JRPP NO:	2010SYW058
DA NO:	DA NO. 298/2011/JP
PROPOSED DEVELOPMENT:	USE OF AN INDUSTRIAL BUILDING FOR THE PURPOSE OF A PLACE OF WORSHIP AND CONSTRUCTION OF A 2-LEVEL CAR PARKING FACILITY
SUBJECT SITE:	LOT 2 DP 1143379 - 219A NORTH ROCKS ROAD, NORTH ROCKS
APPLICANT:	SAE SOON CHURCH C/ BYRNES PDM
LODGEMENT DATE:	25 AUGUST 2010
REPORT BY:	DEVELOPMENT ASSESSMENT CO-ORDINATOR CLARO PATAG
SUBMISSION:	SEVEN (7)
RECOMMENDATION:	APPROVAL SUBJECT TO DEFERRED COMMENCEMENT

ASSESSMENT REPORT AND RECOMMENDATION

ATTACHMENT 15 – VARIATIONS TO SETBACK CONTROLS

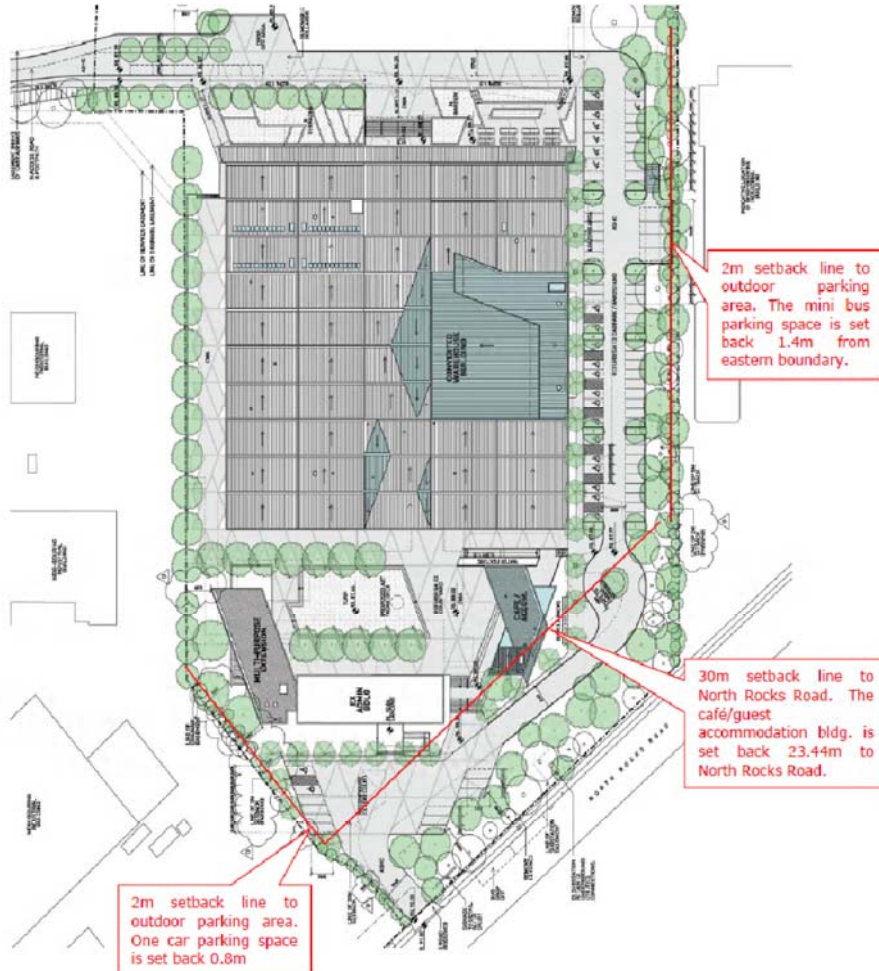
The existing industrial building and administration building are set back 45m and 31m respectively from North Rocks Road. The proposed café/guest accommodation building is set back 23.44m from North Rocks Road and it is considered satisfactory as it would provide adequate areas for landscaping and screen planting and serve as an effective buffer to North Rocks Road. The proposed variation does not impact upon the amenity of adjoining properties in terms of overshadowing and privacy. It is considered that the area of non-compliance is minor as it would be visually non-obtrusive when viewed from North Rocks Road given the slope of the land. The variation is supported in this regard.

Similarly the non compliance on the south-western boundary that adjoins the Unilever site is a function of the shape of the site and is for a very small area. The purpose of the setback is clearly to provide landscaping and ensure that there is an appropriate buffer between adjoining industrial sites. The proposal provides this. Having regard to the minor width of the non compliance and the extensive landscaping provided in the proposal, and that the parking areas are generally screened by landscaping from public places, the minor non compliance is considered acceptable.
